Access Compliance Report Public Rights-of-Way (Curb Ramps)

Intersection ID: N/A Main Street: BEREWICK_COMMONS_PKY Cross Street: LANGWELL_LN Location: N **ADA ID: EBC288CD7337** Ramp Type: Perp Initial Pass/Fail: Fail **Overall Compliance: No Severity Score:** 12.5

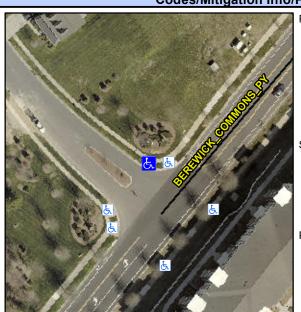
LANGWELL LN Street 1 Name Stop Condition-Street 2 StopSign Street 2 Name N/A Stop Condition-Street 1 N/A Possible Solutions: Remove & Replace Entire Ramp. Surveyor Notes: N/A PROW/ADA: Not Found, R304.5.3

Field Measurements/Component Compliance					
Compliance Description		Data	Comp	liance Description	Data
N/A	Ramp Length (in)	79.0	Yes	Ramp Slope (%)	7.0
Yes	Ramp Width (in)	48.0	No	Ramp XSlope (%)	5.9
N/A	Flare Type LT	N/A	N/A	Flare Type RT	N/A
N/A	Flare Slope LT (%)	N/A	N/A	Flare Slope RT (%)	N/A
N/A	Flare Traversable LT?	N/A	N/A	Flare Traversable RT?	N/A
N/A	Landing Length (in)	N/A	N/A	DWS Provided?	N/A
N/A	Landing Width (in)	N/A	N/A	DWS Contrast?	N/A
N/A	Landing Slope (%)	N/A	N/A	DWS Length (in)	N/A
N/A	Landing X Slope (%)	N/A	N/A	DWS Full Width?	N/A
N/A	Landing Curb? (Y/N)	N/A	N/A	DWS Offset (in)	N/A
N/A	Shared Landing?	N/A			
N/A	Gutter Ponding?	N/A	N/A	Gutter Slope (%)	N/A
N/A	Gutter Lip Ht (in)	N/A	N/A	Gutter X Slope (%)	N/A
N/A	Painted X Walk1?	No	N/A	Painted X Walk2?	N/A
	X Walk 1 Direction	To SW		X Walk 2 Direction	N/A
N/A	X Walk 1 Width (in)	N/A	N/A	X Walk 2 Width (in)	N/A
	X Walk 1 Slope (%)	2.9		X Walk 2 Slope (%)	N/A
